EL PASO COUNTY HEALTH DEPARTMENT
COLORADO SPRINGS, COLORADO

SEWAGE DISPOSAL INSPECTION FORM

LOCATION (street number) 120 Valley St. OCCUPANT Rental (owner Maria Montgomerie)

TO CONSTRUCT, ALTER, REPAIR OR MODIFY AN INDIVIDUAL SEWAGE DISPOSAL SYSTEM

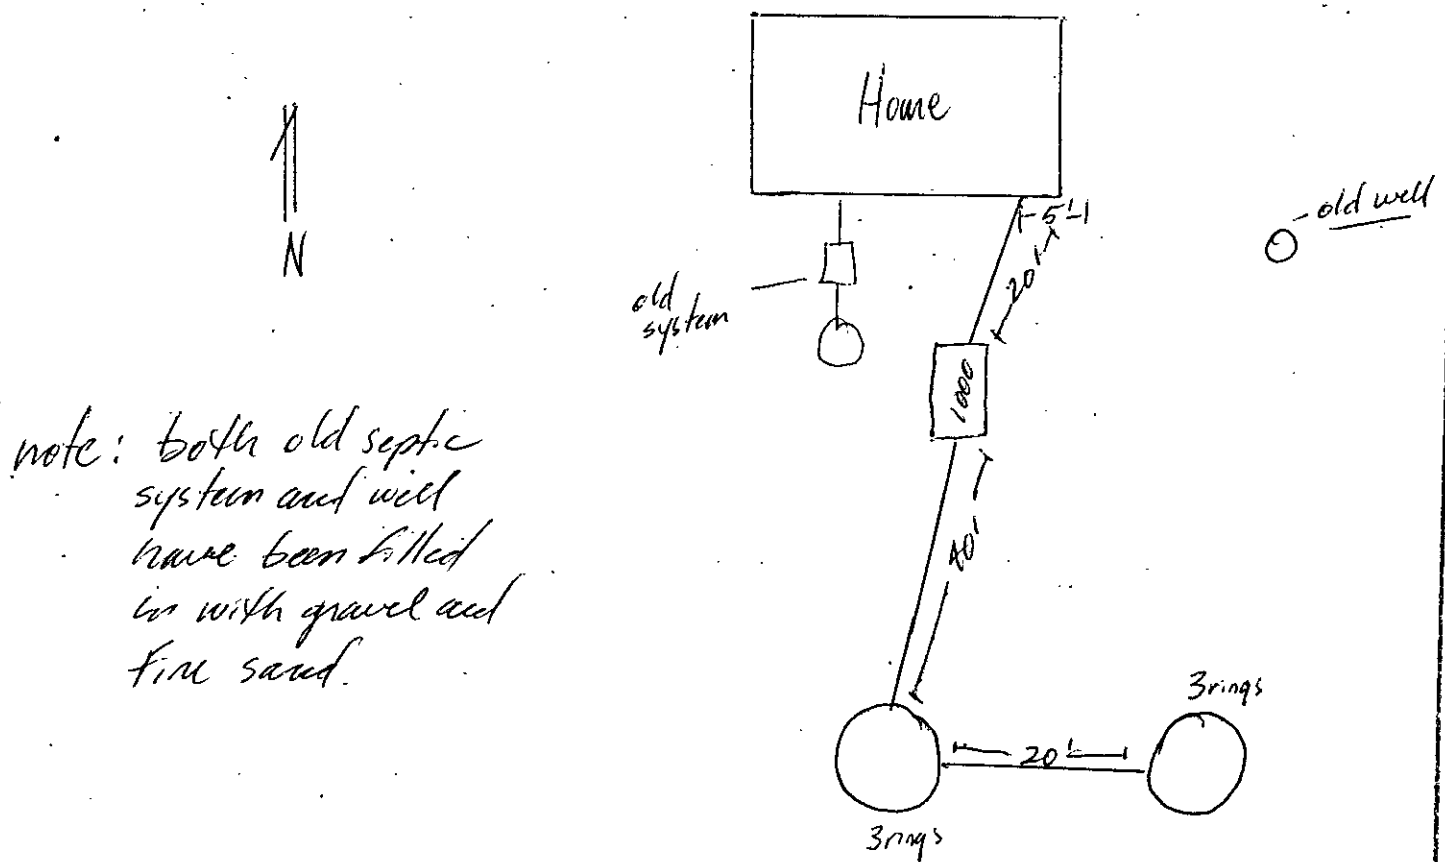
LEACHING PITS (NO.) 2 LINING MATERIAL bedrock CAPACITY SQ. FT. 360 sq. ft.

3 rings in each

note: both old septic system and well have been filled in with gravel and fine sand.
